Western Outer Ring Main Gas Pipeline

Inquiry and Panel Report

8 December 2021

Panel report pursuant to sections 40 and 47

Figure 8 Proposed open trench construction set up for the Jacksons Creek crossing⁸⁷

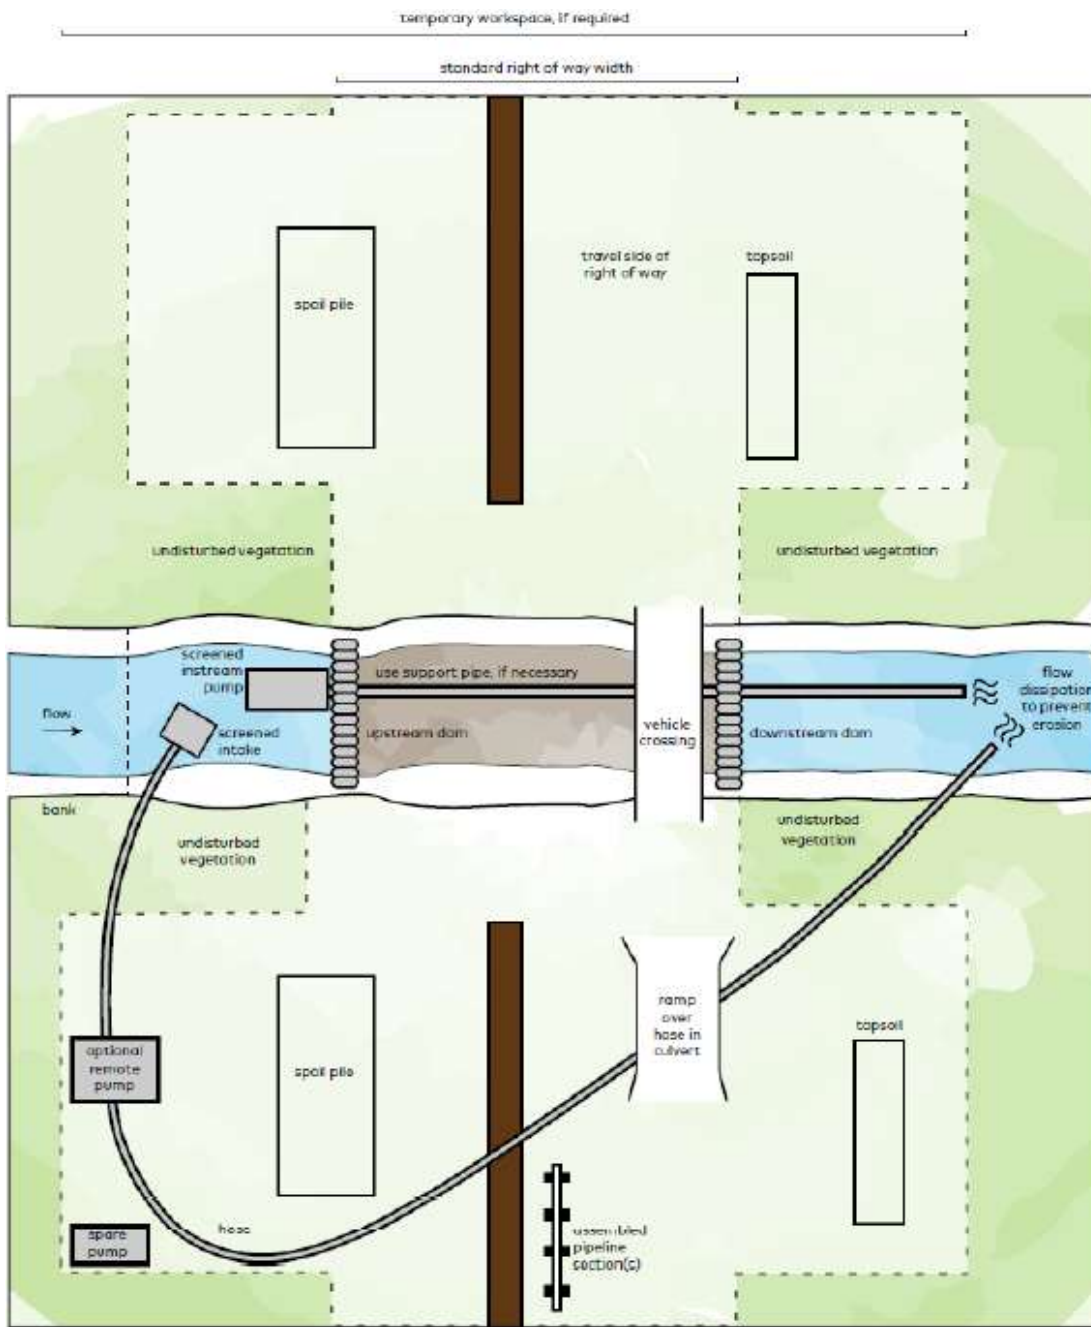
The pipeline (Revision 10) will cross 22 designated waterways, including six 'high risk' waterways, as well as some minor drainage lines that are not designated waterways. The EES lists 23 waterway crossings but reported that Crossing 1 (KP1) does not intersect the pipeline, instead it flows in parallel. The Revision 10 alignment has greater separation between the pipeline corridor and this waterway. The Proponent proposes that the Deep Creek crossing will be constructed by HDD with all the other waterway crossings being constructed by open trenching. Jacksons Creek is the only waterway with perennial flow that is to be trenched. Figure 8 shows the proposed construction approach for the Jacksons Creek crossing.

Figure 11 Quarries and project construction footprint¹³⁵

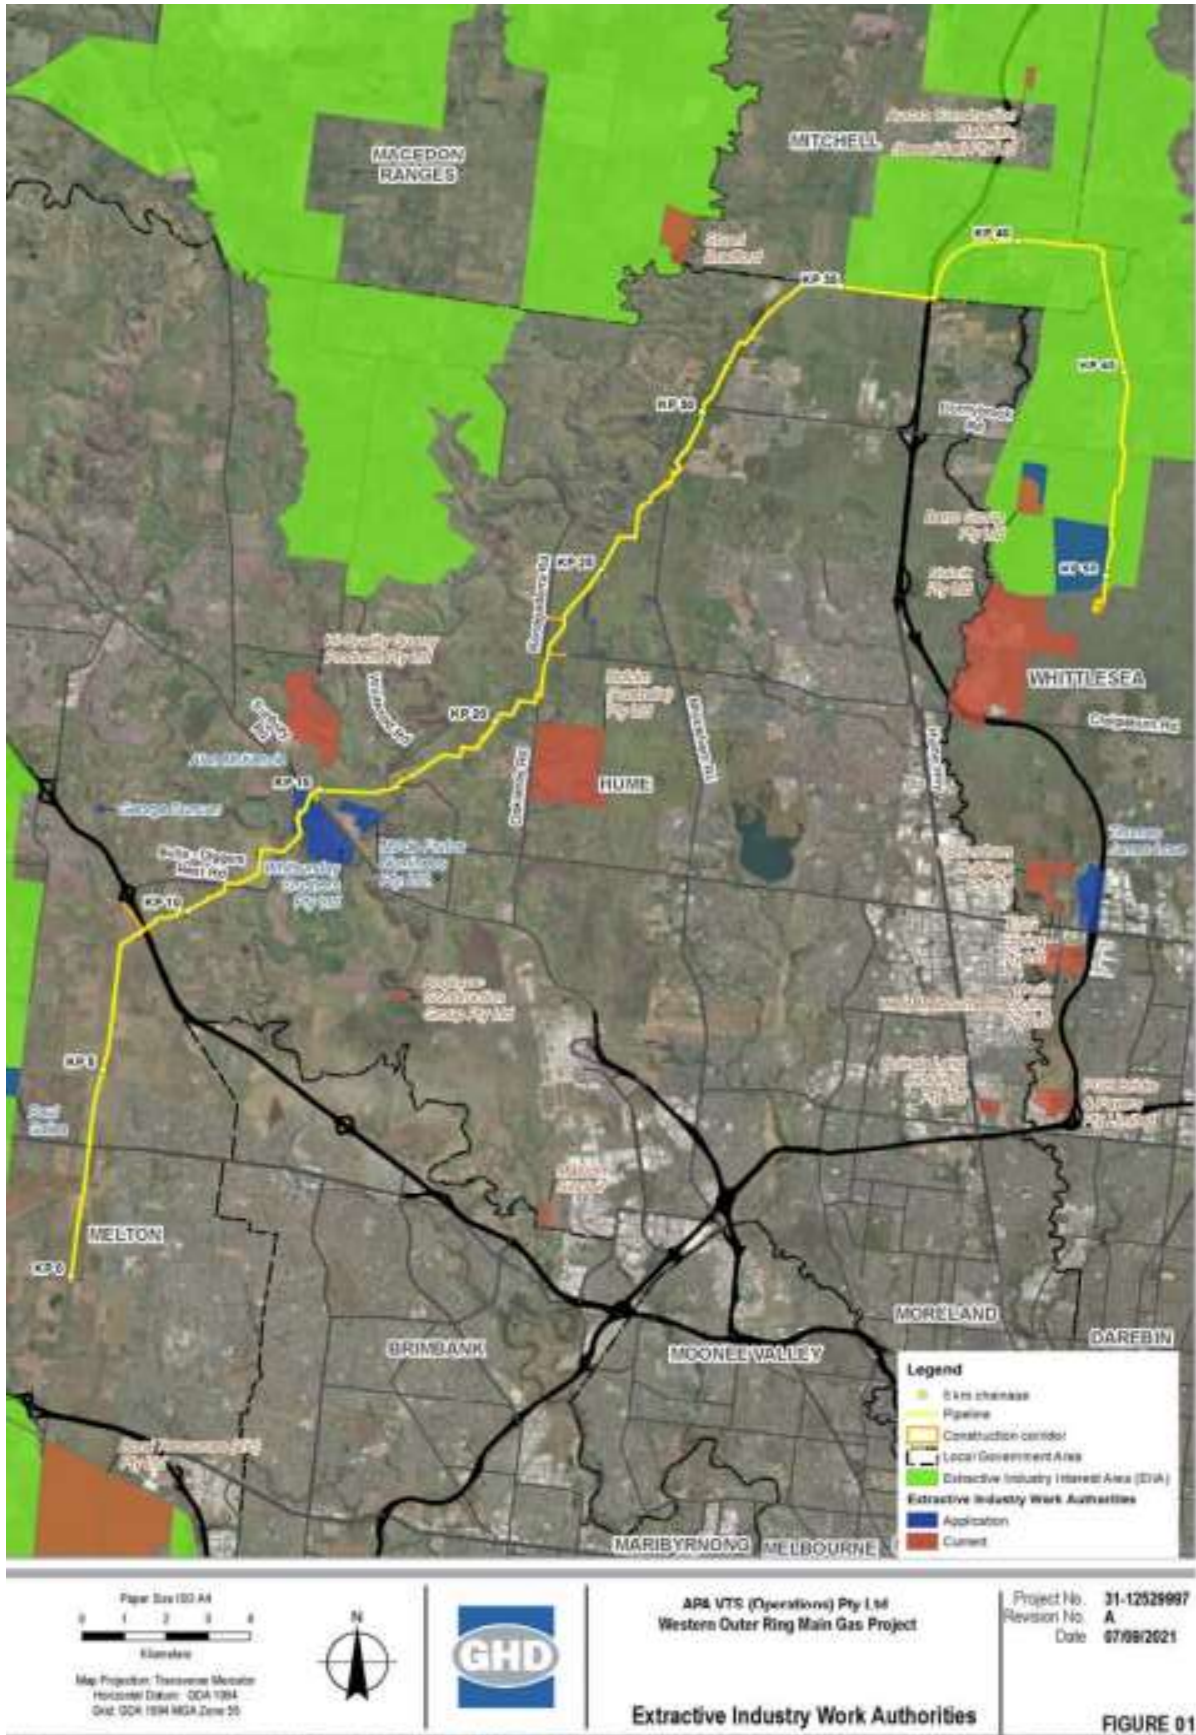
Summerhill Road Land Pty Ltd queried whether the Proponent had assessed the impact of the 'Phillips/Barro Quarry' rock blasting on existing gas pipelines and the Project.

The VPA noted the pipeline would be in close proximity to two future quarries (one in Merrifield North PSP and one in the Northern Quarries PSP). The VPA submitted there was strong policy support for protecting significant extractive industries and the Project should be designed and routed to provide for future resource extraction. It requested the Proponent discuss protection works with the Department of Jobs, Precincts and Regions. At the Hearing, the VPA advised that these issues had been resolved following discussions with the Proponent.

As can be seen from Figure 11, it is evident the pipeline route has for the most part avoided potential conflicts with existing or proposed quarries. Subject to the application of AS/NZS 2885 and appropriate conditions on new quarries, there is no reason to expect that the pipeline would ‘sterilise’ extractive resources or be broadly incompatible with quarrying in the area.

Figure 14 Gunns Gully Road, Merrifield North PSP¹⁵⁴

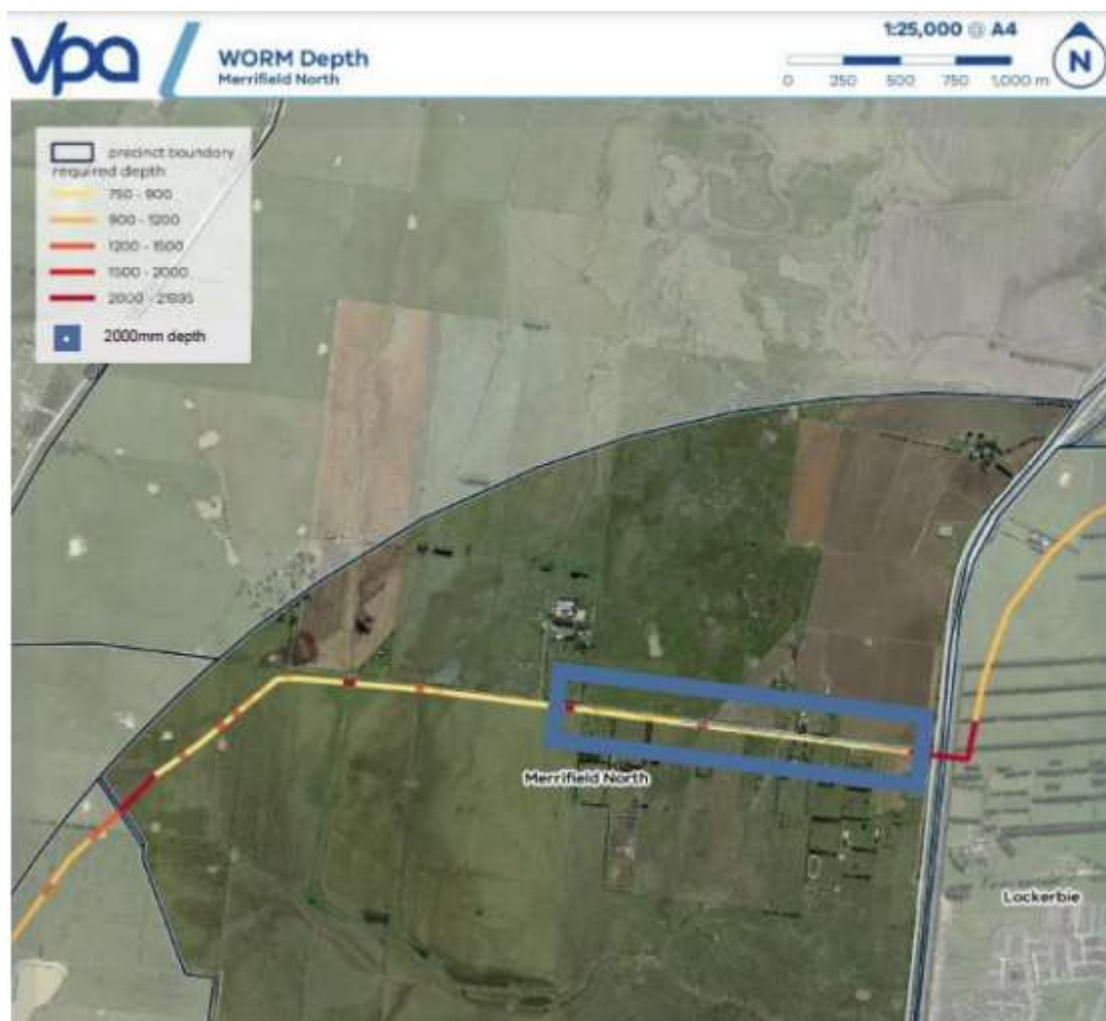
The VPA’s initial written submission raised various issues that were subsequently discussed and resolved with the Proponent. The only outstanding issue at the time of the Hearing related to the depth and coverage of the pipeline along Gunns Gully Road within the Merrifield North PSP¹⁵³ (refer to Figure 14).

Consequently, the VPA sought a recommendation that the depth of cover be two metres for the area between the Melbourne Water retarding basin and the Hume Freeway (shown in Figure 14 as the area in the blue box). If the pipeline was not constructed at this depth, the VPA contended the Proponent should be responsible for any mitigation costs when resolving future conflicts.

- 41** The Proponent should continue discussions with the Victorian Planning Authority and relevant infrastructure agencies to identify any future underground infrastructure along Gunns Gully Road, Merrifield North that would require a change to the pipeline depth. Any relevant infrastructure should be identified by 31 March 2022 and accommodated in the final pipeline design and depth.
- 42** The proposed 'coordination deed' between the Proponent and the Department of Transport should be agreed before the Project's construction commences.
